TO: Jessica McCallum, McDonald's USA, LLC
FROM: Amber Wood Hicken, Planner I
DATE: 12/5/2022
SUBJECT: Parker Pointe F1 L-13 – McDonald's Site Plan Review
Review Comments 01

Staff Comments 01
SP22-089, Parker Pointe
Parker Pointe F1 L-13 – McDonald's Site Plan
11/28/2022

Description: **Parker Pointe F1 L13 - McDonald's Site Plan**

A PORTION OF THE NORTHEAST 1/4 OF THE SECTION 3,
TOWNSHIP 7 SOUTH, RANGE 66 WEST OF THE 6TH P.M.
TOWN OF PARKER, COUNTY OF DOUGLAS, STATE OF COLORADO
SITE PLAN

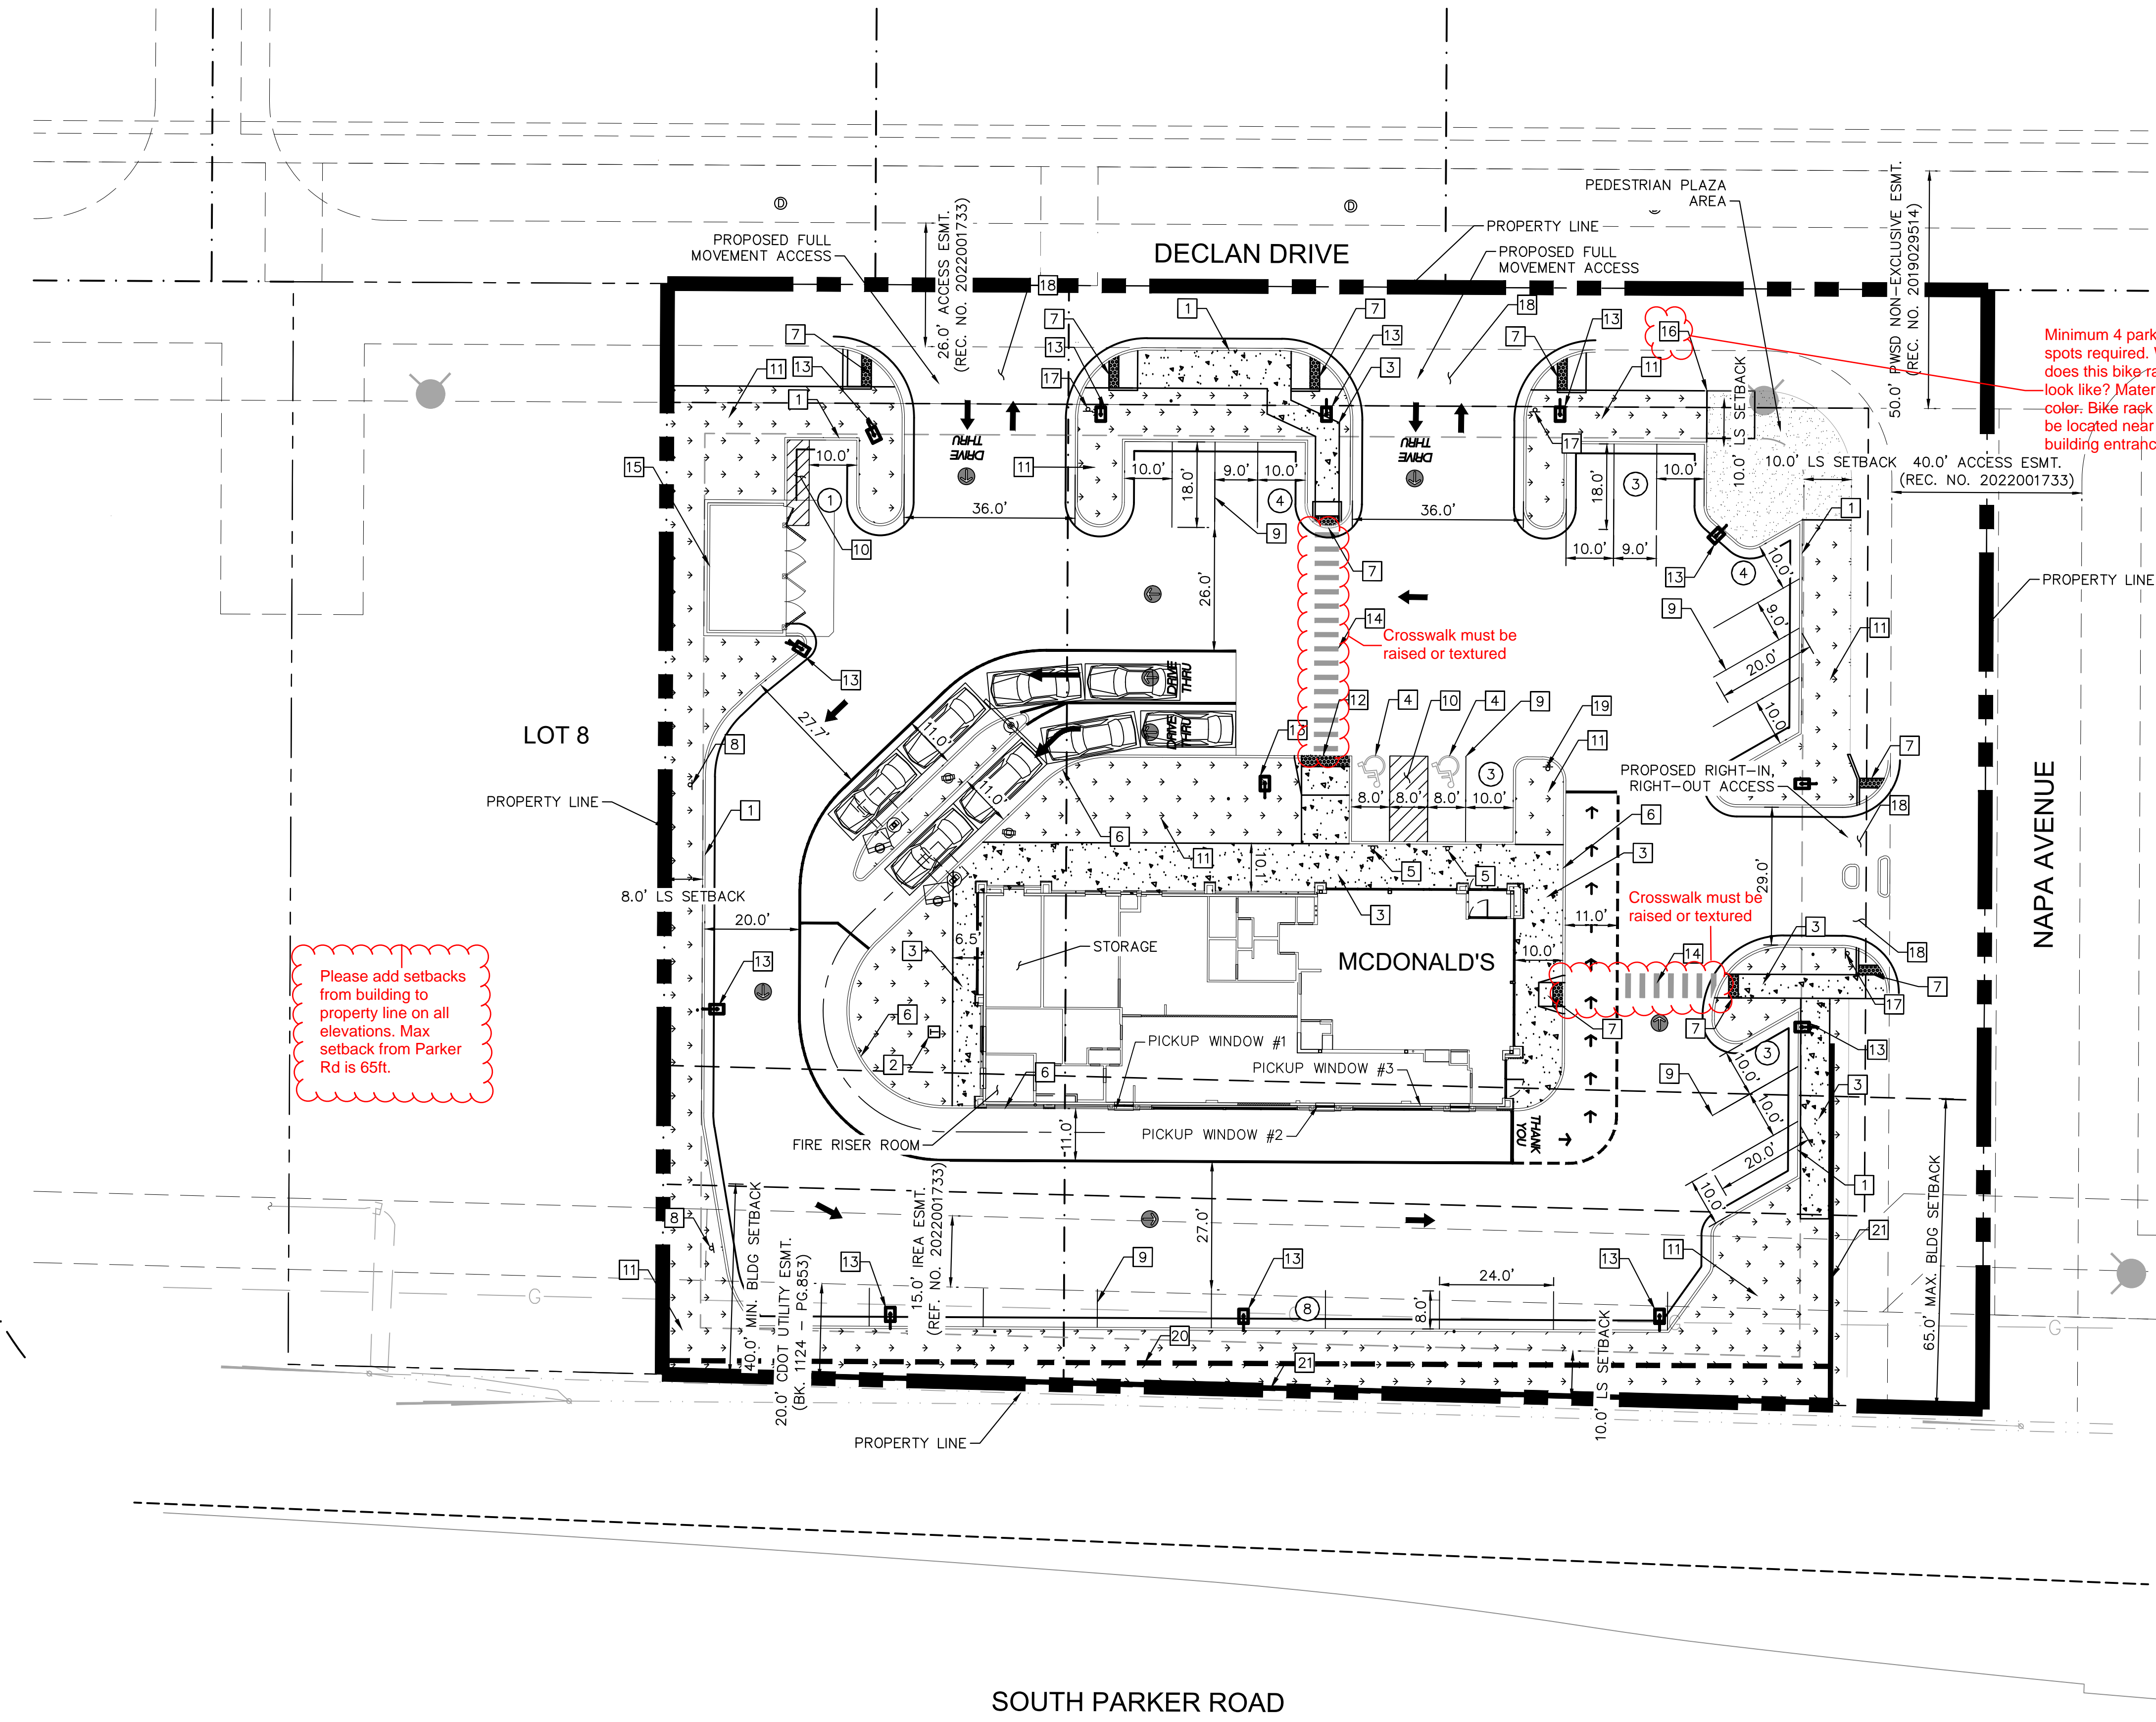
1. The title of the site plan appears incorrect. The title references Lot 7, the subject lot is Lot 13 Parker Pointe Subdivision Filing 1.
2. The vicinity map on the site plan is incorrect. The site is located south of Stroh Rd.

LANDSCAPE PLAN

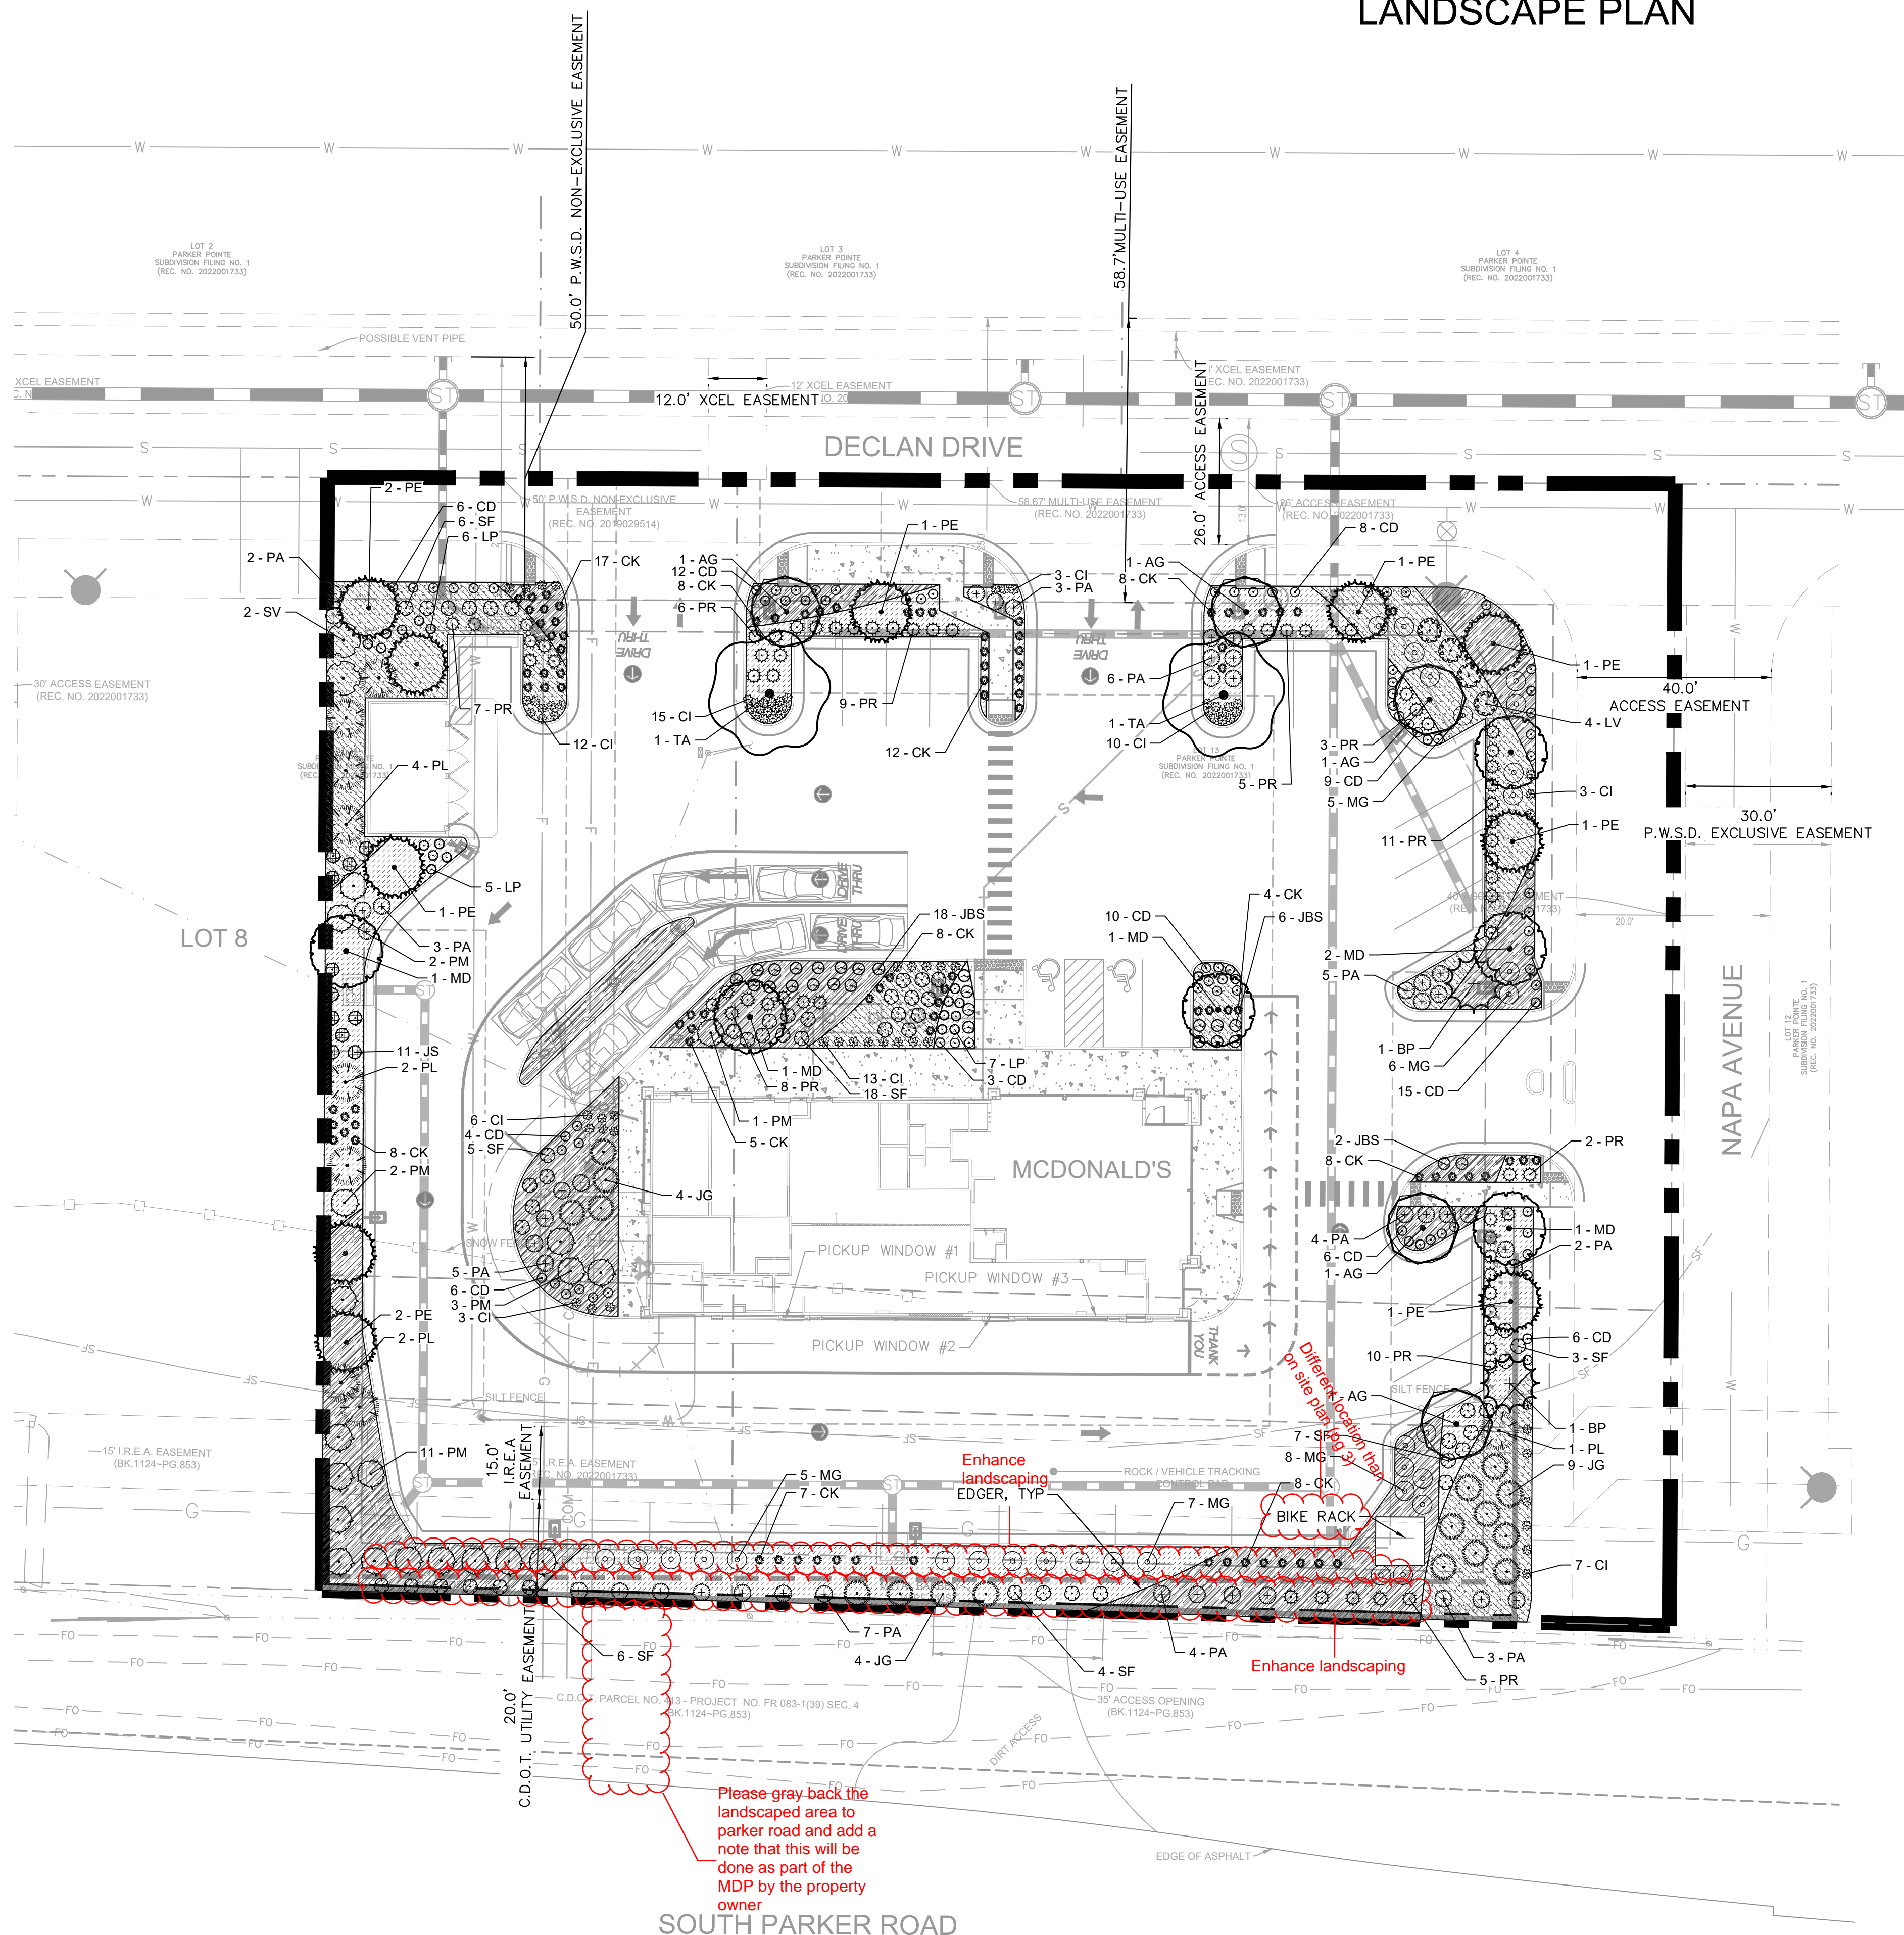
Rock / stone must be two (2) to six (6) inches in size
